<b>Product/Process Change Notice (PCN)</b>		
<input type="checkbox"/> Major Change <input checked="" type="checkbox"/> Minor Change		
<b>PCN Number:</b> PCN_PeRAFU_20251222  <b>Affected Series:</b> WP-RAFU  <b>Affected Part Number:</b> see table "PART NUMBER, REVISION & DATASHEET"  <b>PCN Date:</b> 2025-09-22 (YYYY-MM-DD) <b>Effective Date:</b> 2025-12-22 (YYYY-MM-DD)	<b>Change Category:</b> <input type="checkbox"/> Equipment/Location <input checked="" type="checkbox"/> General Data <input type="checkbox"/> Material <input type="checkbox"/> Process <input type="checkbox"/> Product Design <input checked="" type="checkbox"/> Shipping/Packaging <input type="checkbox"/> Supplier <input type="checkbox"/> Software	
<b>Contact:</b> Product Management  <b>Phone:</b> +49 (0) 7942 - 945 5001  <b>Fax:</b> +49 (0) 7942 - 945 5179  <b>E-Mail:</b> pcn.eican@we-online.com	<b>Datasheet Change:</b> <input checked="" type="checkbox"/> Yes <input type="checkbox"/> No  <b>Attachment:</b> <input type="checkbox"/> Yes <input checked="" type="checkbox"/> No

<b>DESCRIPTION OF CHANGE:</b> <p>Due to an improvement of the production capability, Würth Elektronik eiSos will change the packaging from carton ca

<b>DETAILS OF CHANGE:</b>																						
<ul style="list-style-type: none"> <li>Pictures &amp; dimensions</li> </ul>																						
<b>Before Change</b>	<b>After Change</b>																					
<b>Carton Case (SPQ)</b>	<b>Carton Tray (SPQ)</b>	<b>Shipping Carton (CPQ)</b>

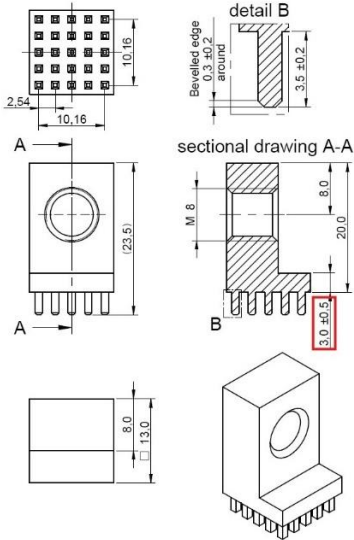
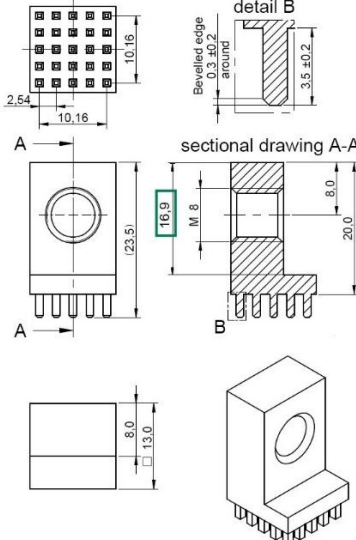
<b>Dimensions (LxWxH):</b>	<b>Dimensions (LxWxH):</b>	<b>Dimensions (LxWxH):</b>																				
108.0 x 85.0 x 65.0 mm	274.0 x 171.0 x 15.0 mm	300.0 x 200.0 x min. 115.0 mm Height varies depending on the component due to two-part carton.																				
<ul style="list-style-type: none"> <li>Datasheet</li> </ul>																						
<b>Before Change</b>	<b>After Change</b>																					
<b>General Information:</b>	<b>General Information:</b>																					
<table border="1"> <tr><td>Material</td><td>Brass</td></tr> <tr><td>Surface</td><td>Tin</td></tr> <tr><td>Execution</td><td>Press-Fit</td></tr> <tr><td>Operating Temperature</td><td>-55 up to +150 °C</td></tr> <tr style="border: 2px solid red;"><td>Packaging</td><td>Bulk</td></tr> </table>	Material	Brass	Surface	Tin	Execution	Press-Fit	Operating Temperature	-55 up to +150 °C	Packaging	Bulk	<table border="1"> <tr><td>Material</td><td>Brass</td></tr> <tr><td>Surface</td><td>Tin</td></tr> <tr><td>Execution</td><td>Press-Fit</td></tr> <tr><td>Operating Temperature</td><td>-55 up to +150 °C</td></tr> <tr style="border: 2px solid green;"><td>Packaging</td><td>Tray</td></tr> </table>		Material	Brass	Surface	Tin	Execution	Press-Fit	Operating Temperature	-55 up to +150 °C	Packaging	Tray

Part Number	Before Change	After Change	
	SPQ: Carton Case	SPQ: Carton Tray	CPQ: Shipping Carton
7461068	81	93	279
7461114	81	93	279
7461115	81	93	279
